ESSEX COUNTY OFFICE OF THE MANAGER

TO: All Bidders
FROM: Linda Wolf, CPA, Purchasing Agent
DATE: November 7, 2016
SUBJECT: Addendum #2 GROUNDWATER MONITORING

This Addendum, issued to bid document holders of record, indicates changes to the bid documents for the *GROUNDWATER MONITORING* Bid Opening November 16, 2016.

**RE: W.O.: # 6310.01
HORACE NYE NURSING HOME,
81 PARK STREET,
ELIZABETHTOWN, NEW YORK
LIMITED SUBSURFACE INVESTIGATION REPORT (SIR),**

FIGURE 1

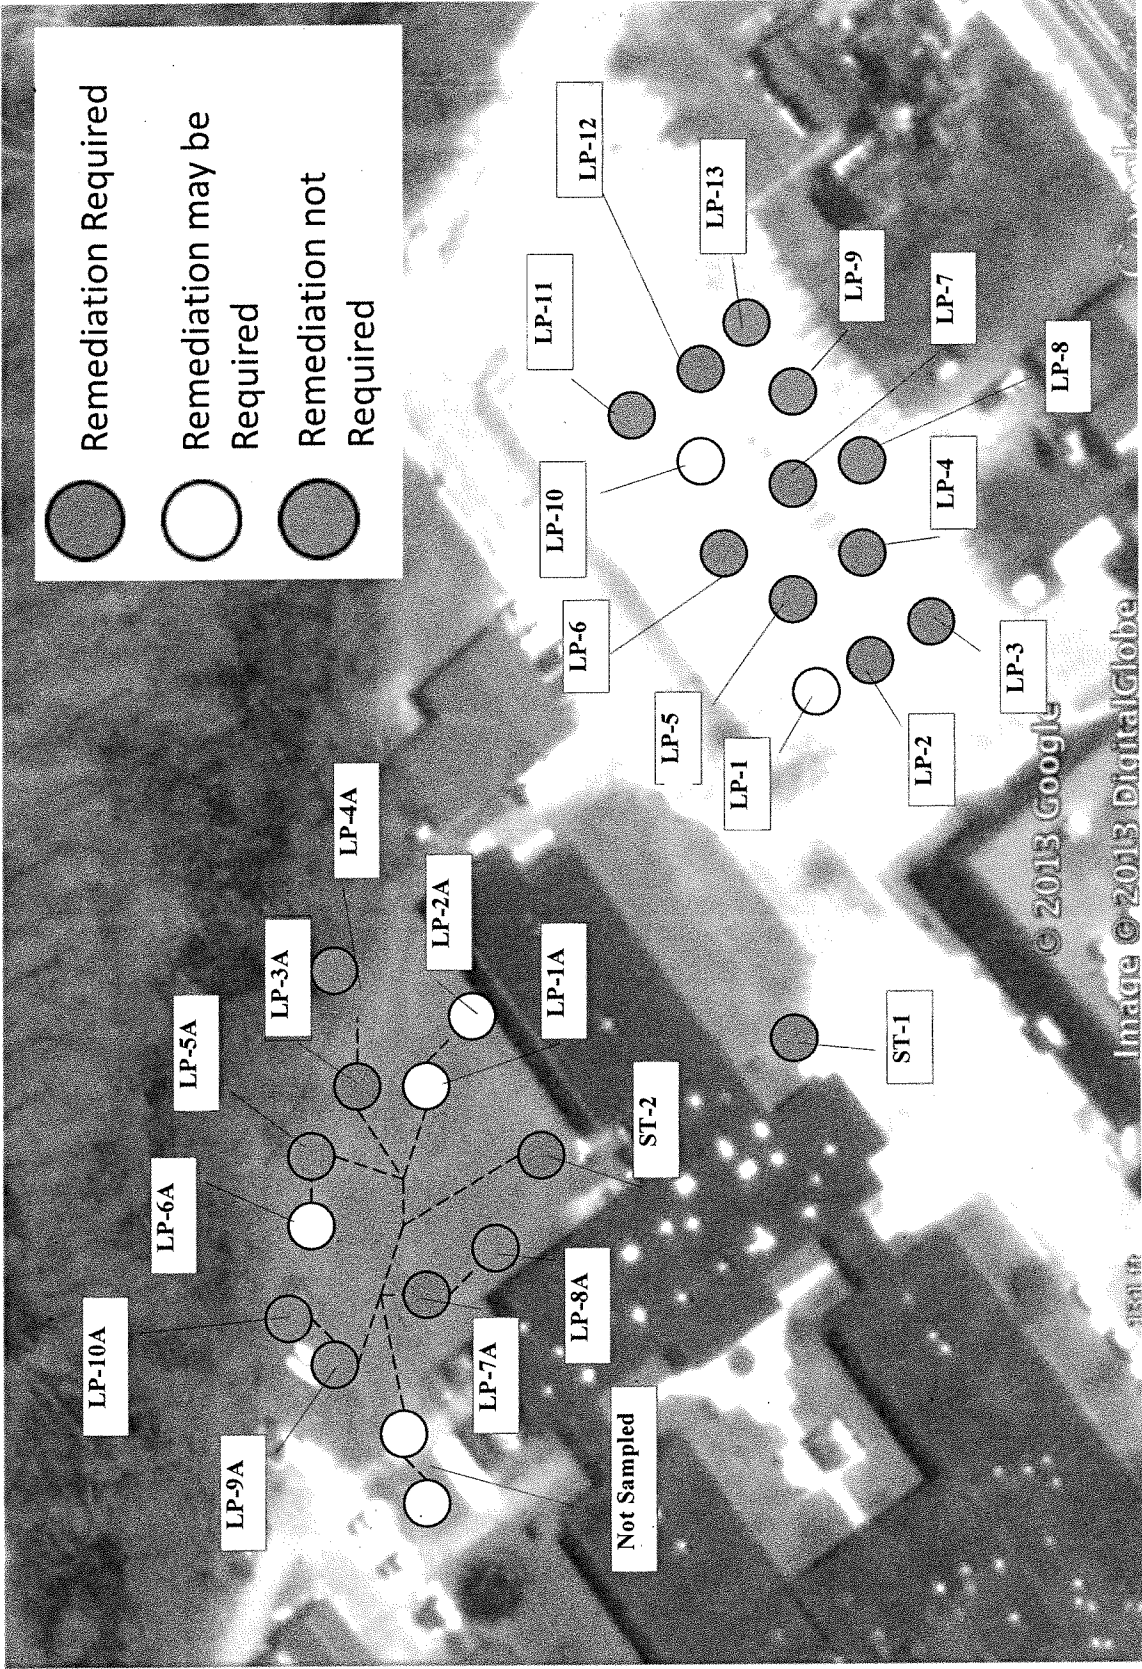
1. Tectonic recommends that Essex County proceed with the site specific requirements set forth by NYSDEC which includes the removal of sediment from impacted seepage pits (see **Figure 1**).
2. Tectonic recommends that additional rounds of groundwater sampling and analyses for toluene, mercury and total phenolics be performed at wells MW-1 (upgradient), and MW-2 and MW-3 (the two downgradient wells with TOGS 1.1.1 exceedances) after sediment removal is completed.
3. Tectonic further recommends that the initial sampling and analytical testing event occur within three (3) months of the aforementioned sediment removal and then proceed biannually for a period of three (3) years thereafter. At the conclusion of the three (3) year sampling period, the cumulative analytical testing results should be evaluated and further recommendations should be provided.

FIGURE 2

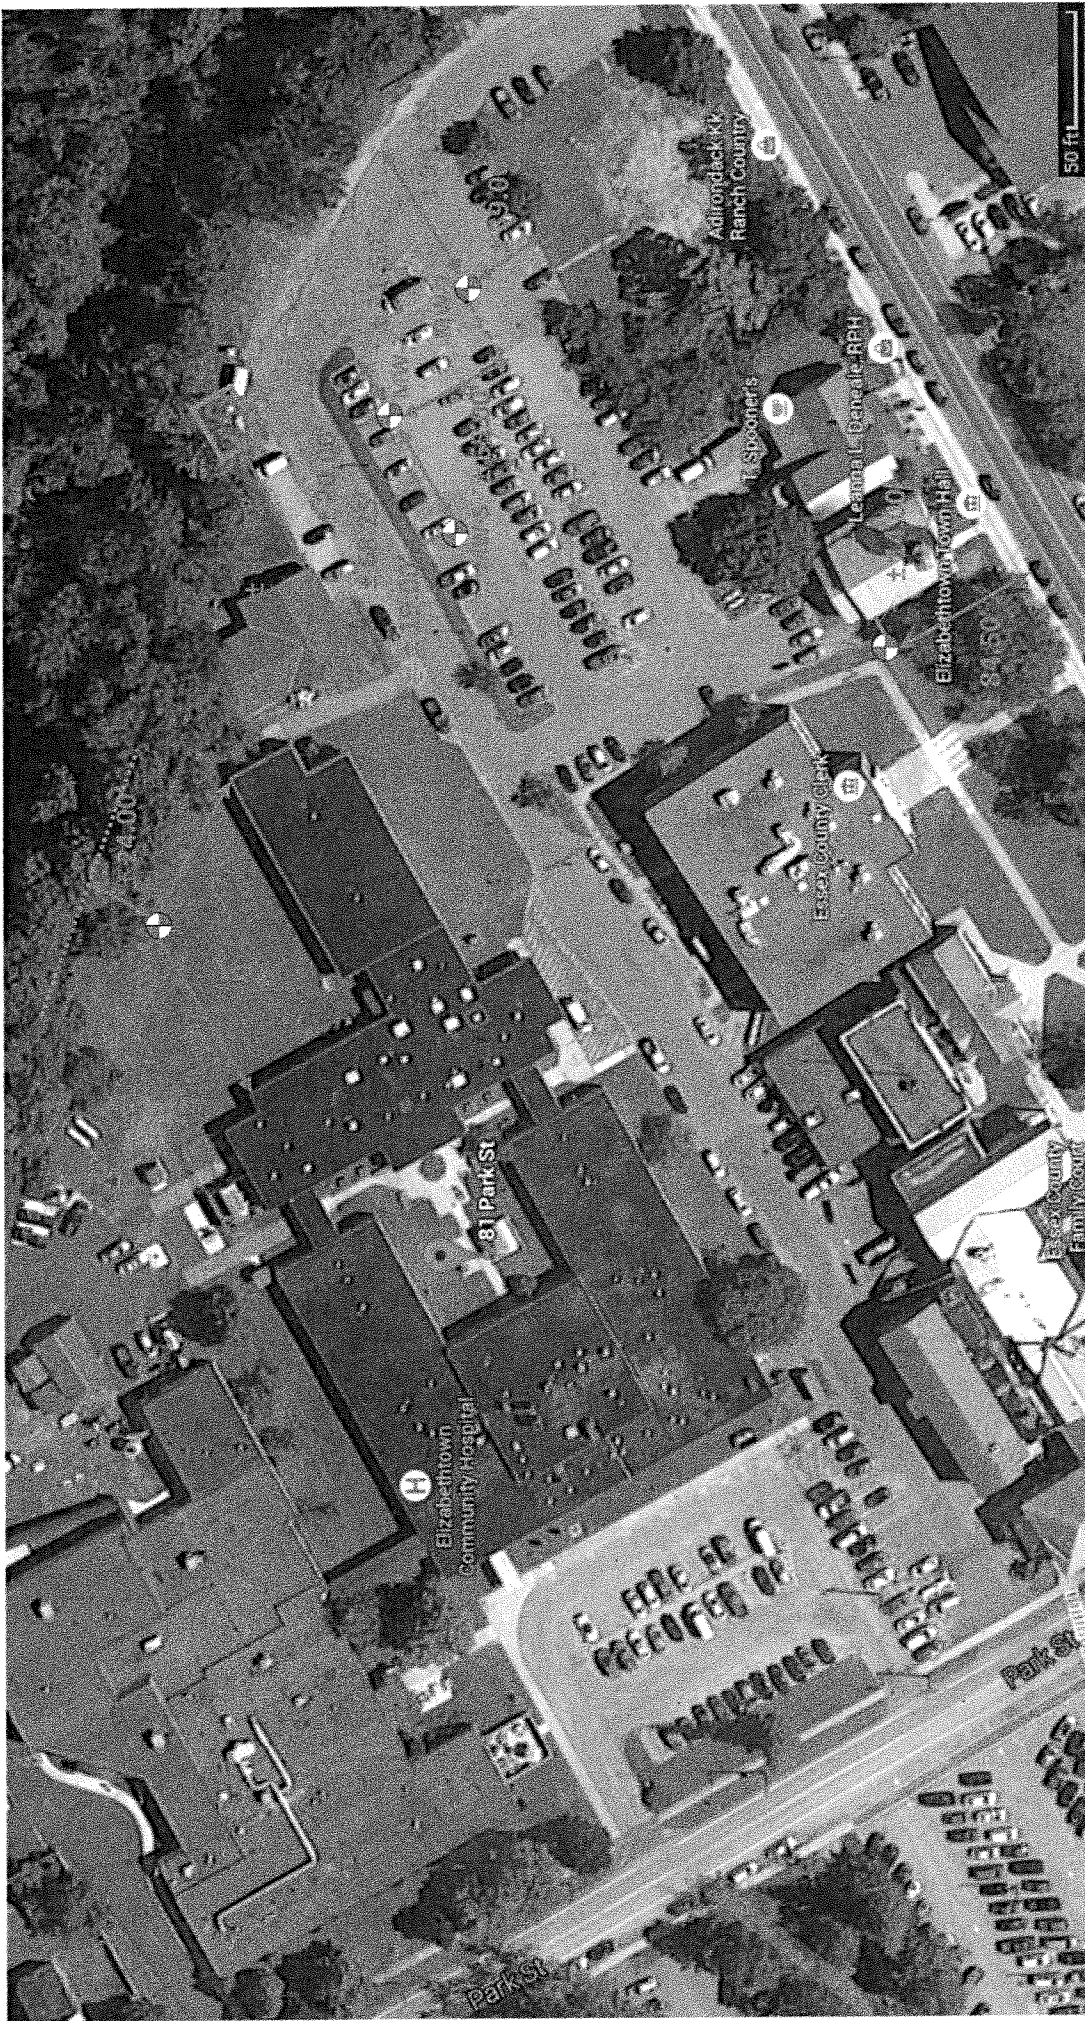
- 4) Based on the language in the proposal, it appears that all wells can be accessed by a vehicle?

9) How deep are the wells and what is the distance between each well? Do you have previous measurements for water table levels?

10) Have the wells been surveyed? Do we have base maps?

13) Is there access to electricity at the site?

16) Is it possible to park a vehicle next to the wells, or will materials and equipment need to be brought to the site on foot?

Answer - See Figure 2 attached.

Answer - For depths of wells and distance between wells, See Appendix 1 and Figure 2 attached. For previous measurements of water table levels see water level measurements sketch dated 6/1/16 attached.

Answer - No survey has been completed, however, See Appendix 1 and Figure 2 attached.

Answer - See Figure 2 attached. The residential style building located between MW-4 and MW-5 is the workshop for the Essex county Buildings and Grounds department, 120 volt electrical power is available at that location for limited use by groundwater monitoring contractor.

Answer – See Figure 2 attached.
